P 53701
A Upgrade

ON-SITE SEWAGE DISPOSAL SYSTEM TANK REPLACEMENT HOWARD COUNTY HEALTH DEPARTMENT BUREAU OF ENVIRONMENTAL HEALTH

ADDRESS: 17501 Woodcamp Road PROPERTY OWNER: Alex and Andrea Nibert

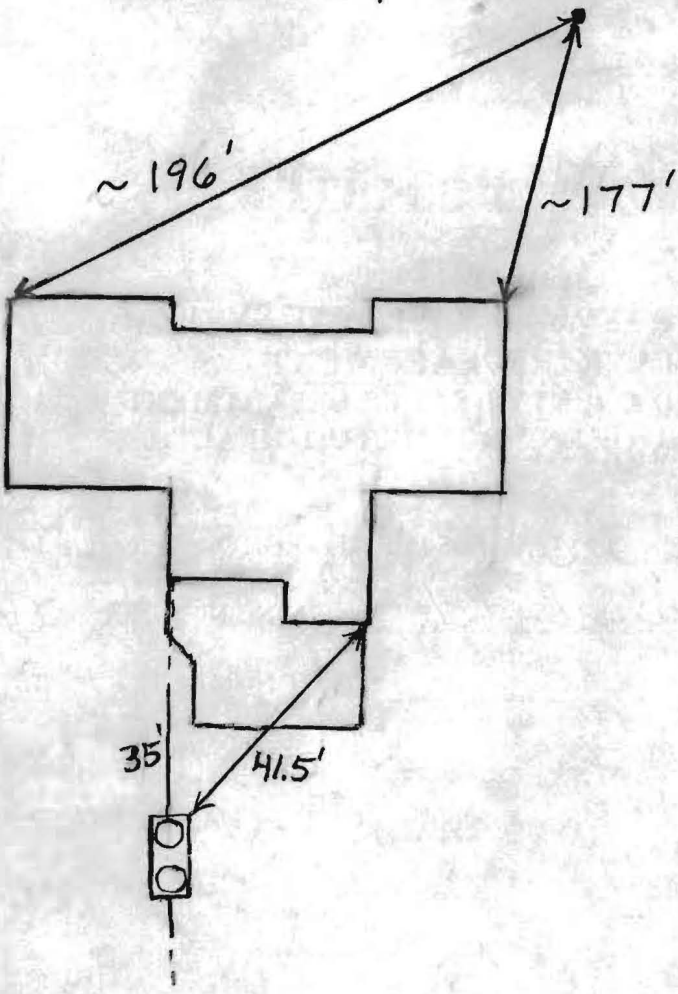
5/16/2012 Cannot use existing tank because it is right next to deck. I install a new

2000 gallon two compartment tank at least 10' from the deck. Pump out and abandon old tank. (BB)

5/17/2012 New tank installed. Old tank abandoned. Told installer to put riser on rear of tank since tank didn't come with a 6" adapter. (BB)

Change gate
this
wall

trench either way
of test hole closest
to house ok; to follow
bed ground ±

Septic tank location ok 7.5'
